**CITY OF EAST PROVIDENCE  
WATER MAIN CLEANING AND LINING PHASE V REBID  
RFP EP23/24-26R**

**ADDENDUM # 2 – OCTOBER 9, 2024**

The following revisions, clarifications, additions and/or deletions are hereby made a part of the Bid Documents for the City of East Providence's Water Main Cleaning and Lining Phase V Rebid project, RFP EP23/24-26R.

SHEET NO. 10 OF 26

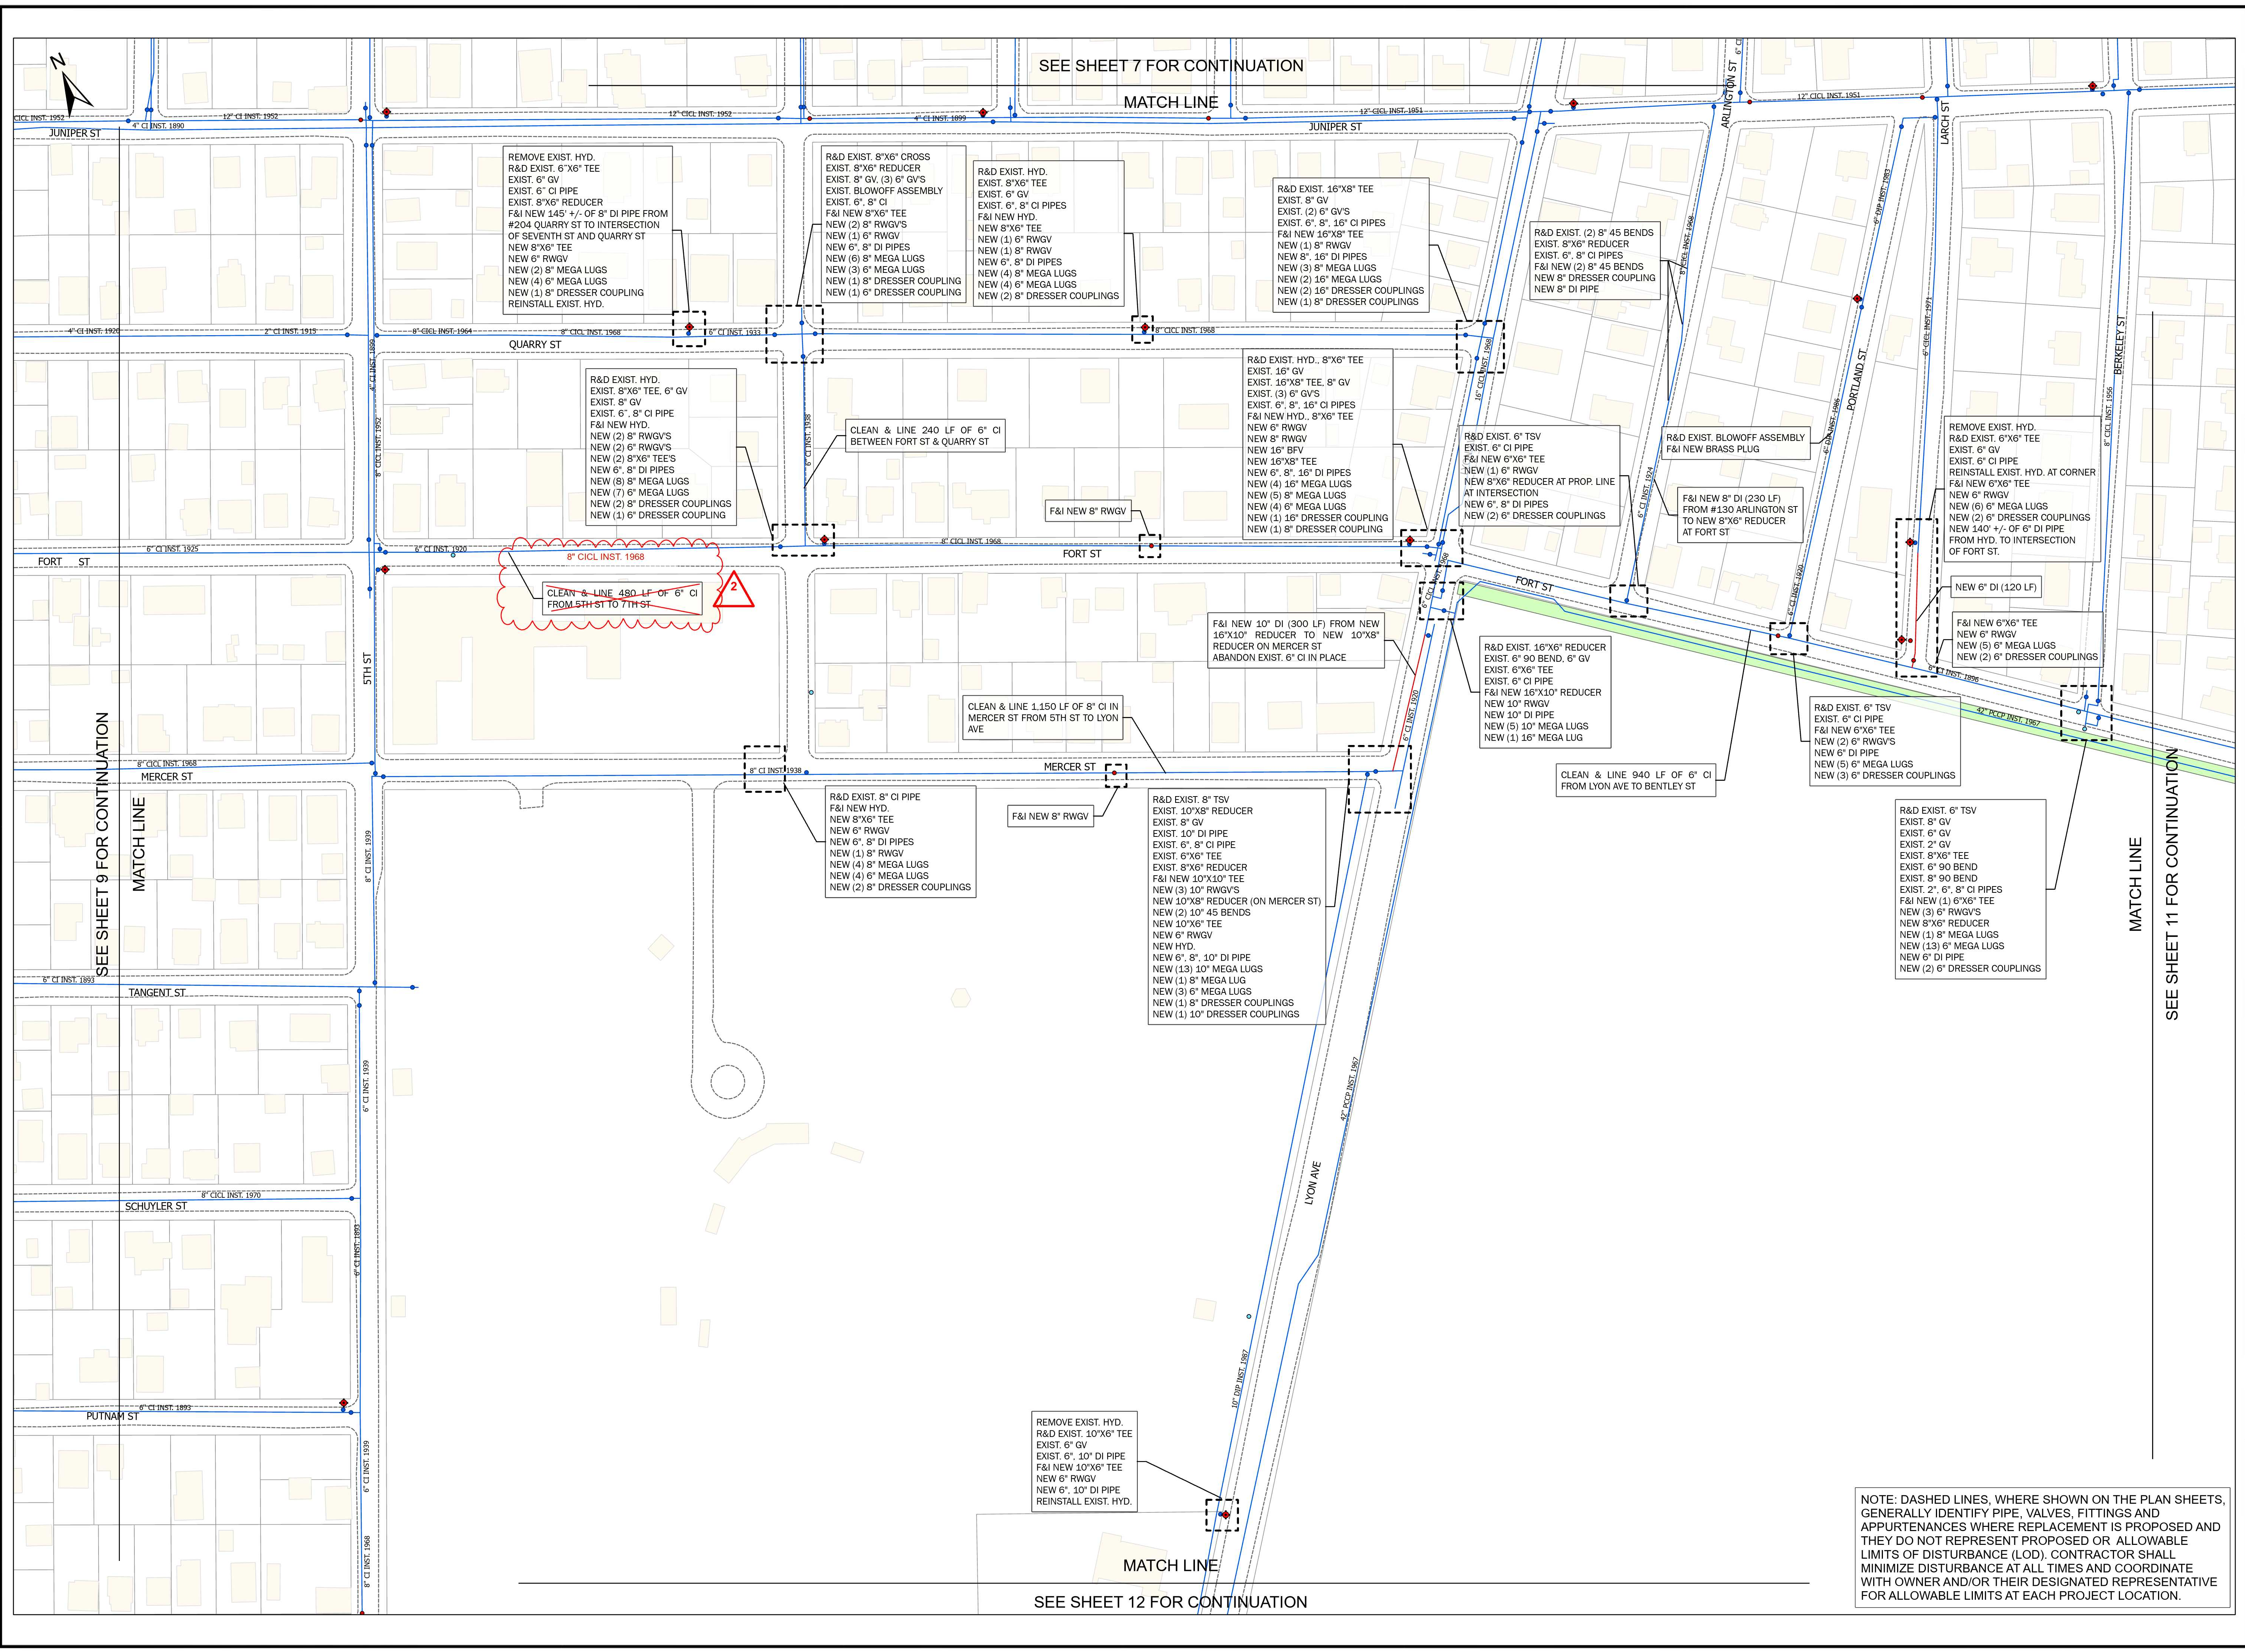
6. Sheet 9/10
  - a. Is Tangent Street west of 1<sup>st</sup> a dead end?
  - b. At Fort St. near 5<sup>th</sup> St. it states that to F&I 160’ of 8” DIP from #104 to intersection of 5<sup>th</sup> St. On Sheet 10 it says c & cml from 5<sup>th</sup> St to 7<sup>th</sup> St. Which one is it? Are there two mains?

**Installation of approximately 160 linear feet of new 8-inch ductile iron in Fort Street, from 5<sup>th</sup> Street easterly to an existing 8”x6” reducer, is proposed. The existing 8” water main east of this reducer does not require cleaning and lining. However, cleaning and lining of an approximately 480’ section of 6” CI water main in Fort Street, between Burgess Avenue and 5<sup>th</sup> Street, has been added. These sheets have been revised accordingly. Please refer to attached Sheets C2.5 and C2.6 revised by Addendum No. 2.**

SHEET NO. 11 OF 26

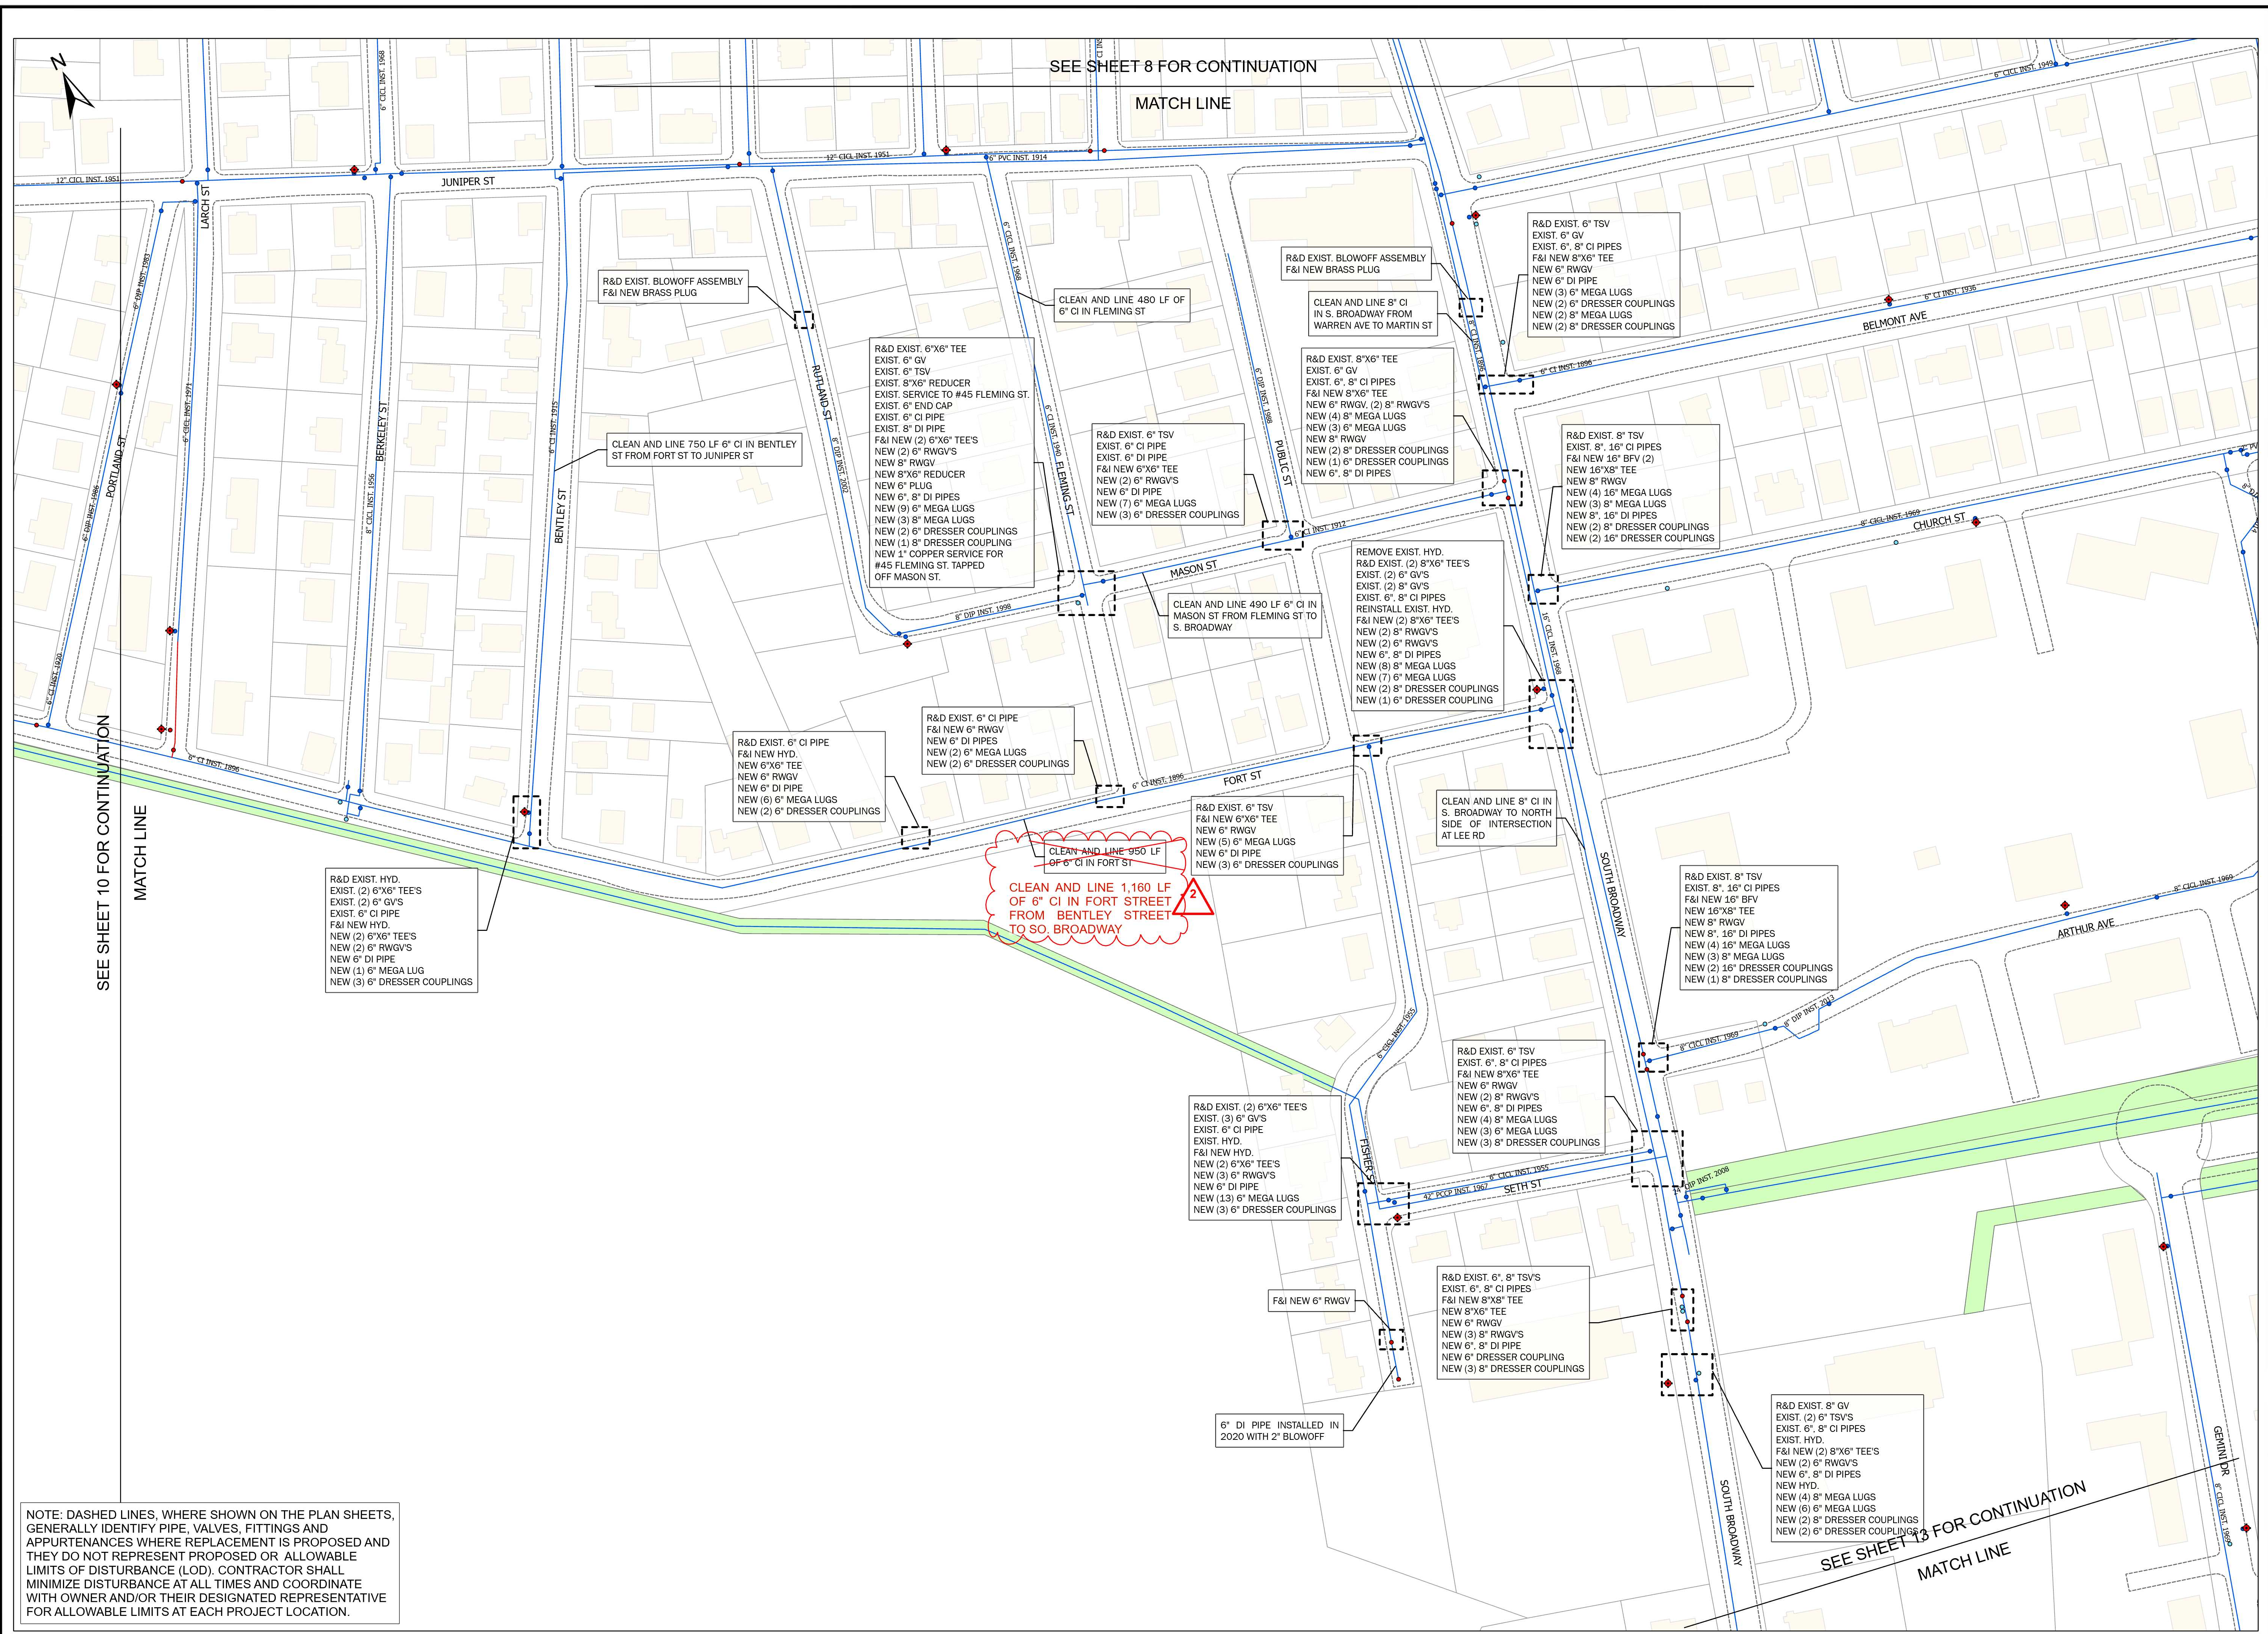
7. Sheet 11 – What are the limits of work for the 950’ of cleaning and lining of the 6” main on Fort Street?

**An approximate 2,100 linear feet of 6” cast iron on Fort Street, between Lyon Avenue and South Broadway, is proposed to be cleaned and lined. Approximately 1,160 linear feet of**

**this is east of Bentley Street. The notation on Sheet 11 has been revised accordingly. Please refer to attached Sheet C2.7 revised by Addendum No. 2.**
